SUBJECT: PLANS AND PROPOSAL ADDENDUMS

PROJECT: CM 2023(611)

CONTROL: 0092-02-137

PROPOSAL ADDENDUMS

IH45 ITS UPGRADE LAYOUT

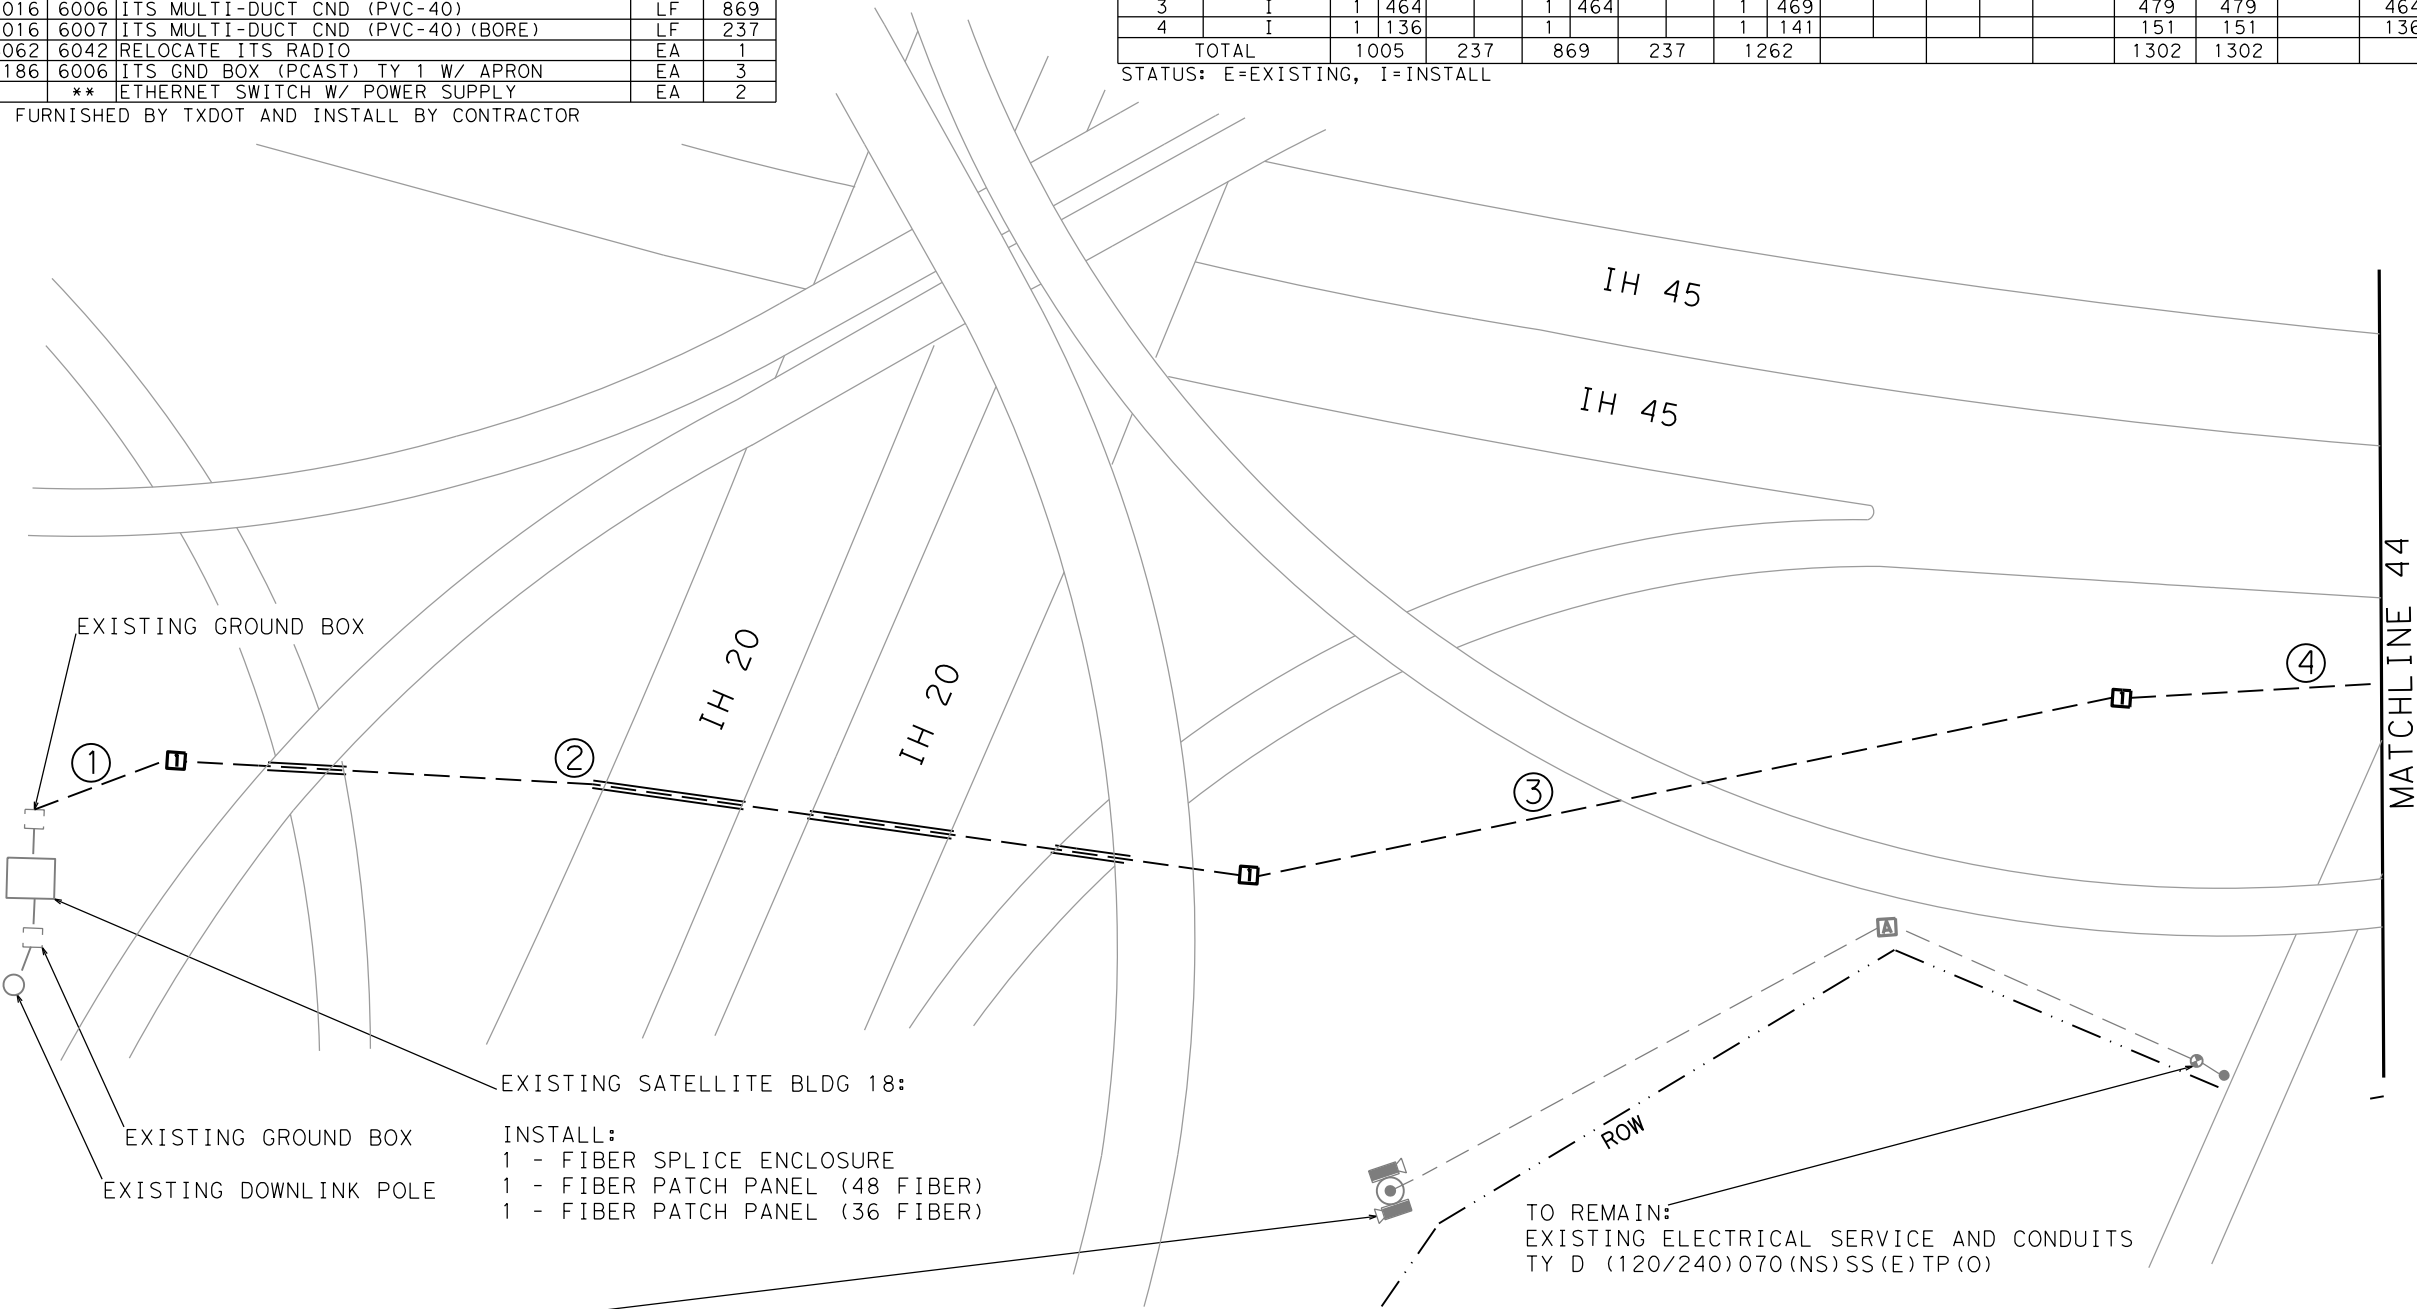
*****bid inserts*****
adjusted quantities for the following bid items:628-6151,6062-6042
added following missing bid items:624-6028,628-6002,6064-6019
*****plans sheets*****
Sheet 4,4a,5,5a,5b: updated bid items and quantities
Sheet 6a: updated sheet
Sheet 7: updated bid items 628-6002,628-6151,624-6028,6062-6042,6064-6019
Sheet 12: added bid item 628-6151
Sheet 17: added bid item 628-6151
Sheet 22: updated bid items 624-6028,628-6002,628-6151,6062-6042,6064-6019
Sheet 38: updated bid items 624-6028,628-6002,628-6151,6062-6042,6064-6019
Sheet 50: added bid item 6062-6042

RELOCATE:
1 RELOCATE ETHERNET RADIO POINTED SOUTH TO WINTERGREEN AND INSTALL ON PROPOSED RVSD POLE AT MALLOY BRIDGE.
